ADDENDUM NO. 2

MARCH 5, 2018

The following minutes are intended to provide a summary of the issues and topics discussed relevant to the Pre-Bid Conference for the Facility Security Upgrade project at the Muhlenberg High School and Middle School. All attendees are requested to review the information and notify Muhlenberg Greene Architects of any needed corrections or additions to these minutes. These Pre-Bid Meeting Minutes have been attached to Addendum #2 for the referenced Project and are to be considered part of the Bidding Documents.

MIDDLE SCHOOL	MUHLENBERG SCHOOL DISTRICT FACILITY SECURITY UPGRADES 801 BELLEVUE AVENUE READING, PA 19605
SD-002	
PARTITION PLAN

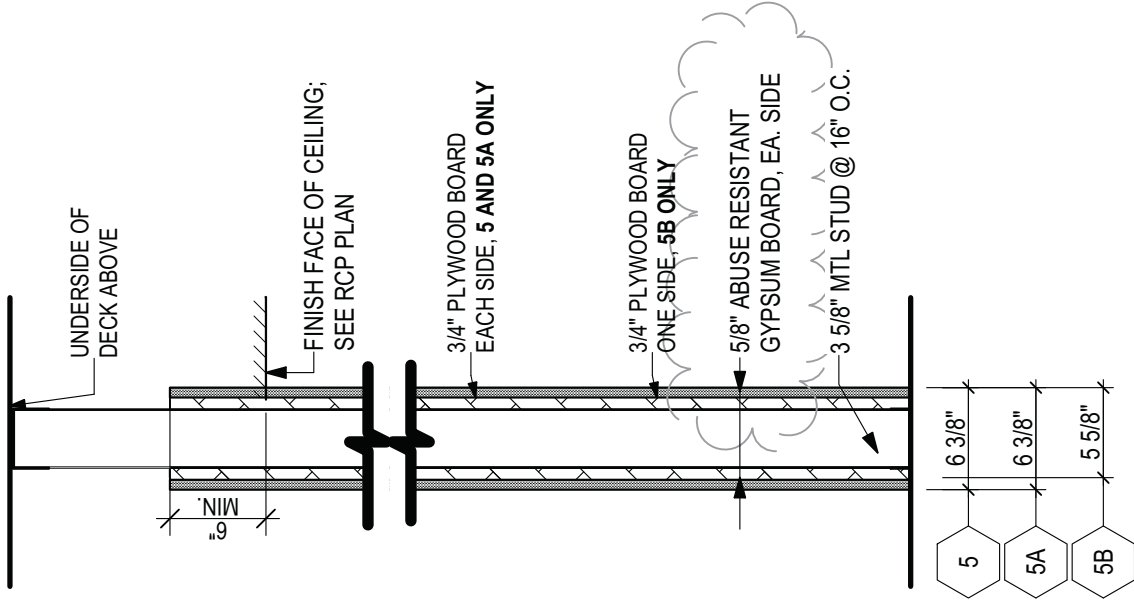
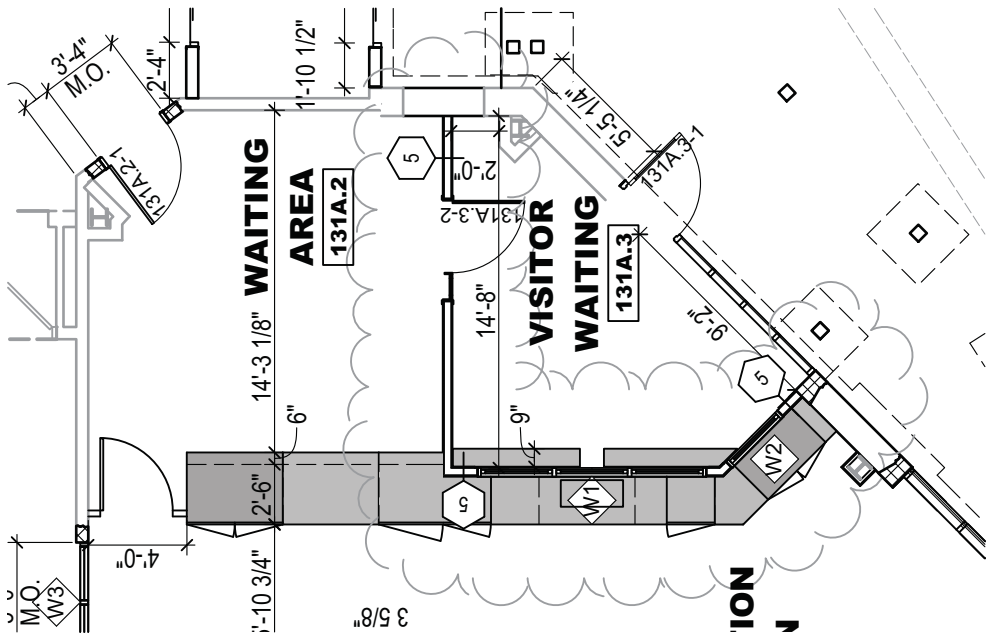
1. **Drawing AM-105**: Revise partition types for rooms in library as shown on drawings SD-001 and in the visitors waiting as shown on SD-002.
2. **Drawing AM-601**: Revise partition type 5 as shown on SD-002.

HIGH SCHOOL	
MUHLBERG SCHOOL DISTRICT	
FACILITY SECURITY UPGRADES	
801 BELLEVUE AVENUE READING, PA 19605	
SD-003	PARTITION TYPE

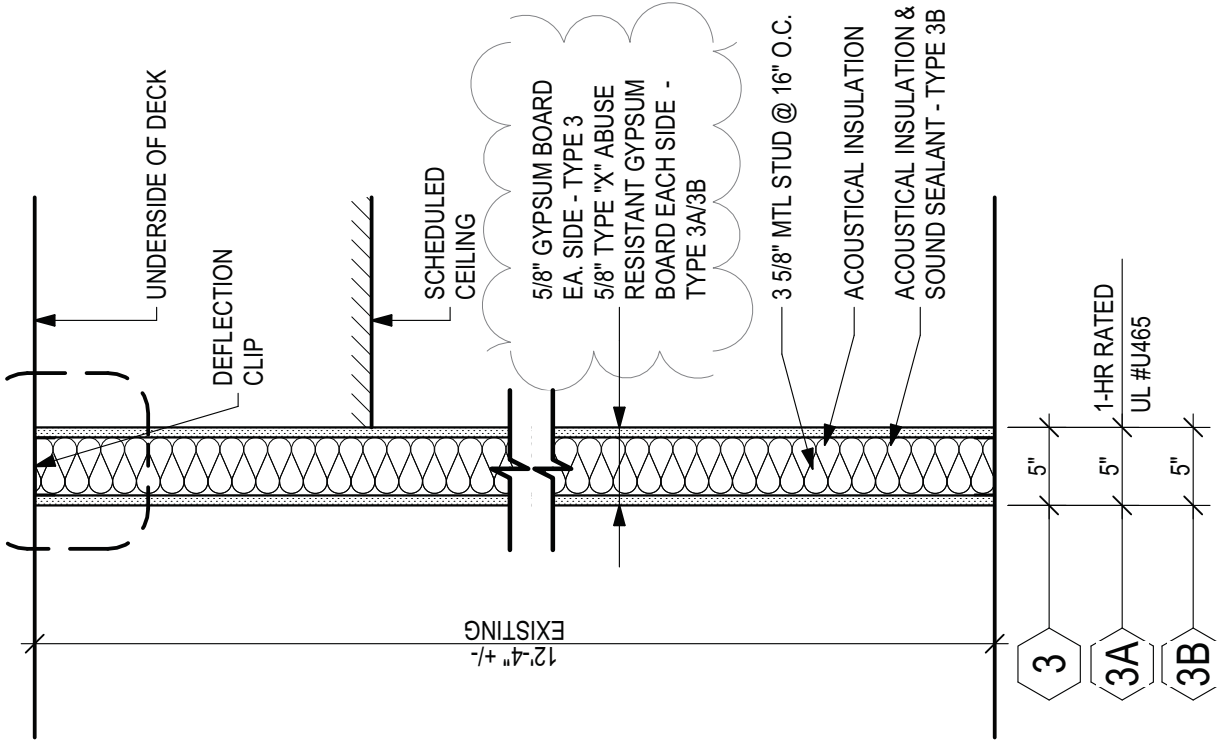
3. **Drawing AH-603**: Revise partition type 3A and 3B as shown on SD-003.
4. **Drawing AH-404**: Change keynote 10.21.1 to keynote number 12.32.5 on Detail 1 “Kitchenette Elevation” and Detail 2 “Section Detail @ Sink”, keynote shall read as follows:

MIDDLE SCHOOL	
MUHLENBERG SCHOOL DISTRICT	
FACILITY SECURITY UPGRADES	
801 BELLEVUE AVENUE READING, PA 19605	
SD-004	PARTIAL DEMOLITION PLAN

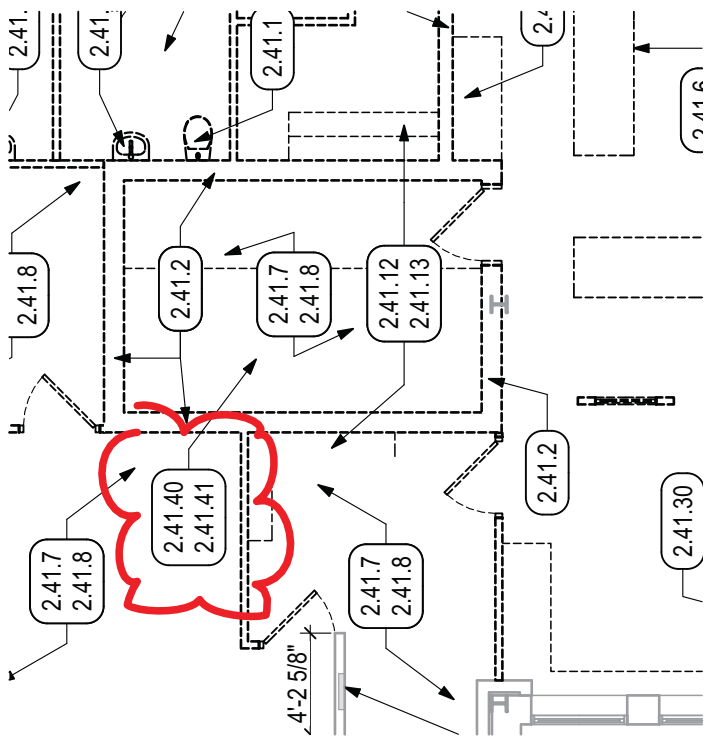
11. **Drawing AM-102:** Added notes to indicate careful removal and storage of existing sliding file cabinet and track and store for reinstallation, see SD-004.

- 2.41.27**
REMOVE EXISTING TILE AND MORTAR BED DOWN TO EXISTING CONCRETE SLAB.
- 2.41.30**
REMOVE EXISTING WALL DESK / COUNTER IN ITS ENTIRETY.
- 2.41.40**
CAREFULLY REMOVE EXISTING SLIDING FILE CABINETS AND TRACKS AND STORE FOR REINSTALLATION, BY G.C..

MIDDLE SCHOOL	
MUHLBERG SCHOOL DISTRICT	
FACILITY SECURITY UPGRADES	
801 BELLEVUE AVENUE READING, PA 19605	
SD-005	PARTIAL DEMOLITION PLAN

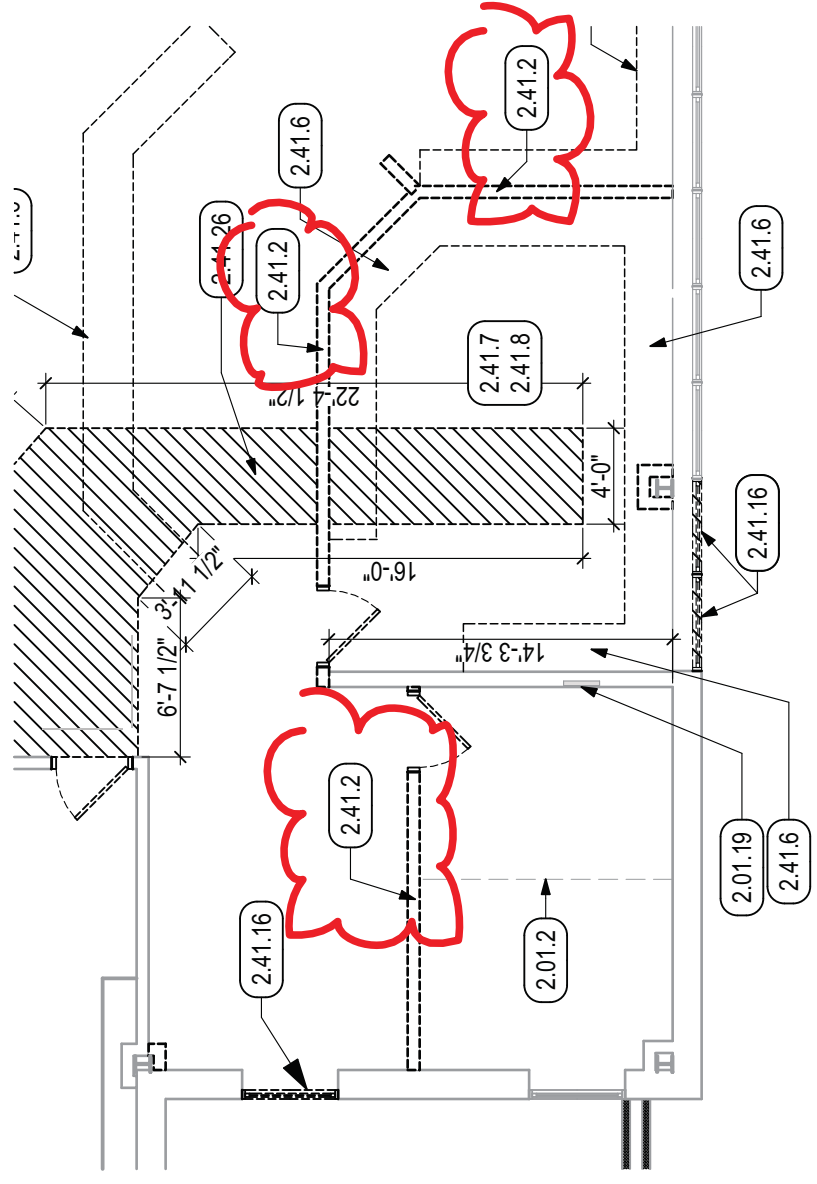
12. **Drawing AM-102:** Added additional keynotes to clarify the removal of existing masonry walls, see SD-005.
13. **Drawing AM-104:** Showed location for reinstallation of existing sliding file cabinets and track, see SD-006.

SD-007

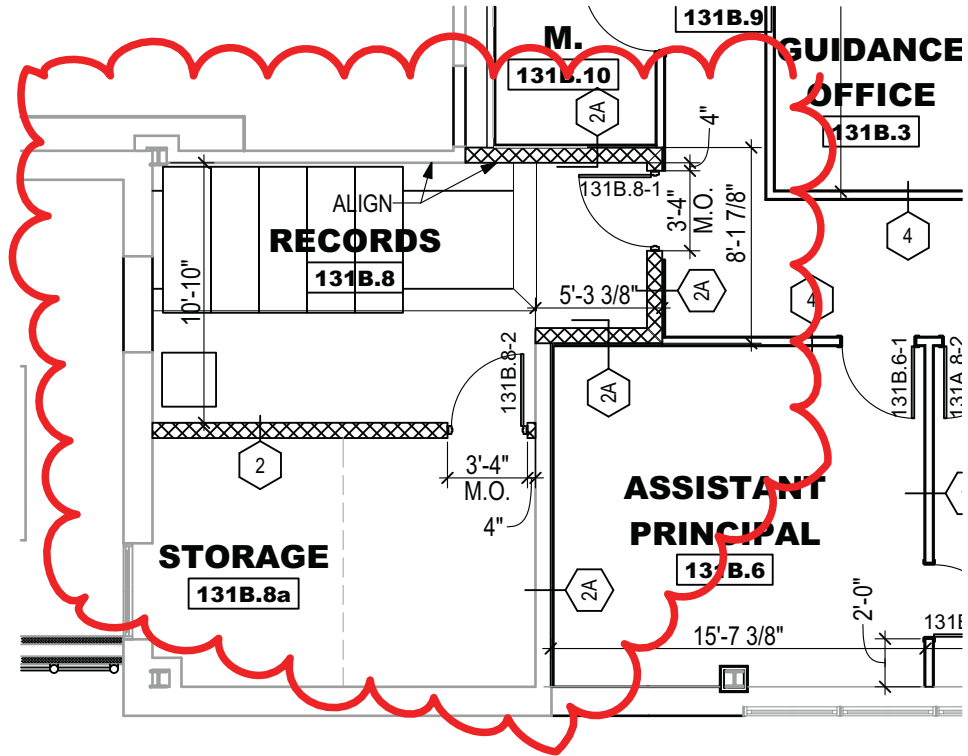
14. **Drawing AM-105:** Provided additional dimension for walls that were relocated to accommodate sliding file cabinets, see SD-007.
15. **Drawing AH-106:** The existing roof at the high school is a modified bituminous membrane roof manufactured by the Garland Company. Patching of the existing roof is to be performed by a contractor authorized by the roofing manufacture to maintain the existing warranty. The school districts preferred roofing contractor is GSM Roofing, 345 South Reading Road, Ephrata, PA 17522, (800) 532-ROOF (7663).

FIRST FLOOR PLAN
SCALE: 1/16" = 1'-0"

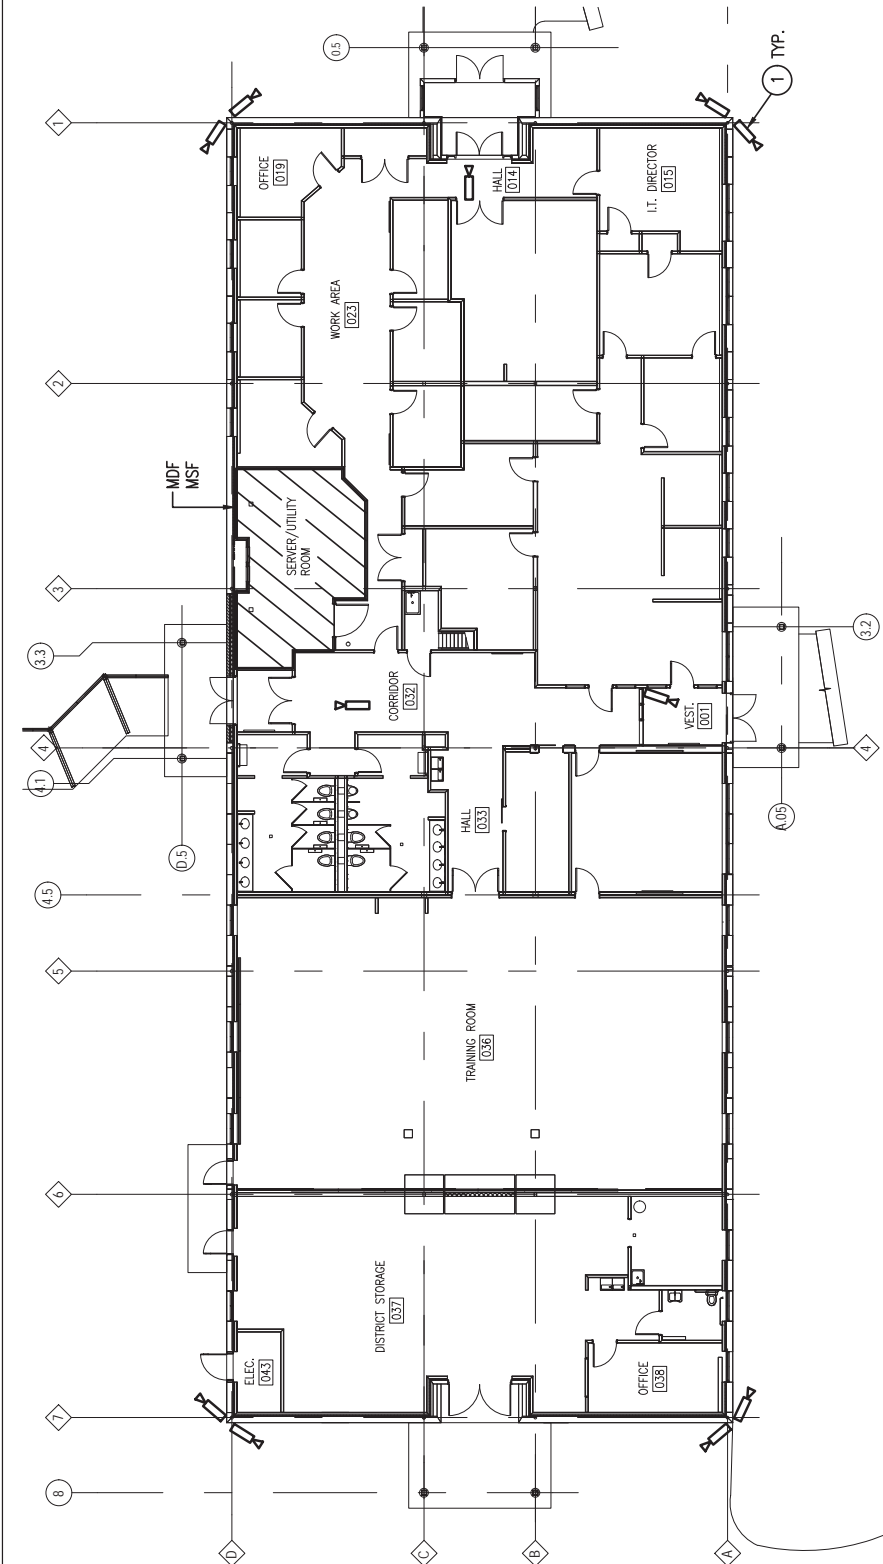
21. **Drawing E-301 Generator Plan and Details**; refer to Sketch **SKE-1**, being issued with this addendum, for CCTV camera data wiring work required in the Blue Center building under this contract.

1. CAMERA DATA SHALL BE RUN TO SERVER/UTILITY ROOM (MDF/MSF).
